**BEFORE THE NATIONAL GREEN TRIBUNAL, PRINCIPAL BENCH, NEW  
DELHI**

**OA 2456 of 2022**

**SUBMISSION OF HUMAN RIGHTS FORUM, ANDHRA PRADESH**

Figure 2 Typical laboratory tailing deposition test results

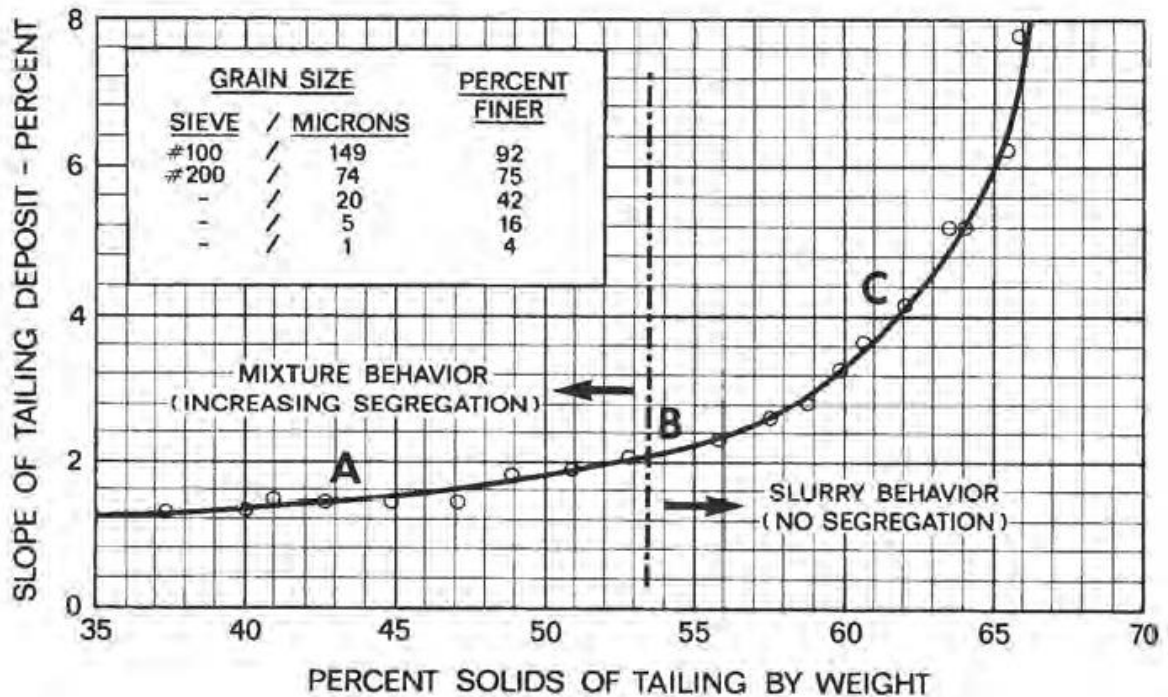
“As a tailing is thickened it progressively changes from a mixture of solid particles and liquid to a non-segregating slurry. The state at which the latter occurs is the minimum percent solids to which any tailing must be thickened. Typically, a slurry of this consistency will stand at slopes of 1 to 2 percent. Additional thickening will result in steepening of the deposited slope at an ever-increasing rate. Figure 2 illustrates typical laboratory tailing deposition test results.” Tailings qualify as thickened after point B in Figure 2.

Fig. 4. Single primary clay liner over a LDS.

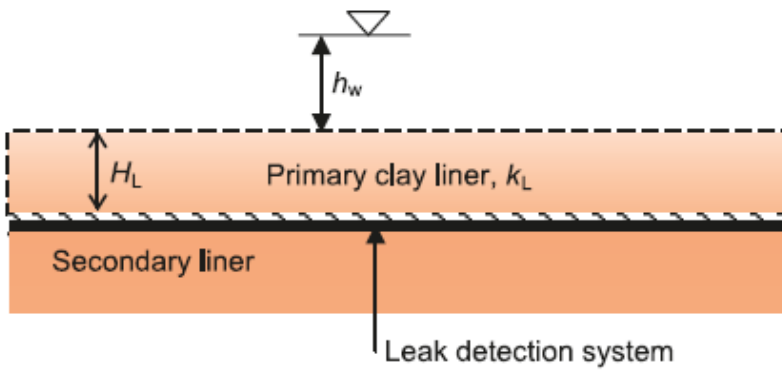
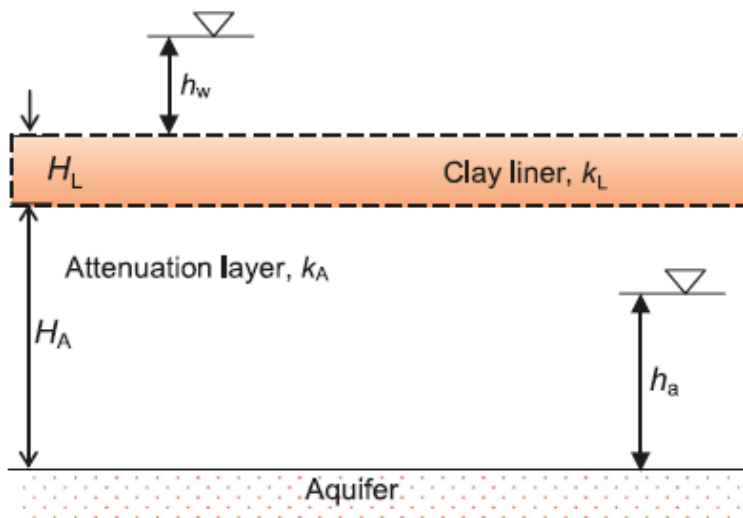
Attenuation layer is the normal soil layer in between the lining and the groundwater table.

$H_A$  is the thickness of the soil layer or the depth of the water table below the surface in m.

$h_a$  is the piezometric head in m of the groundwater
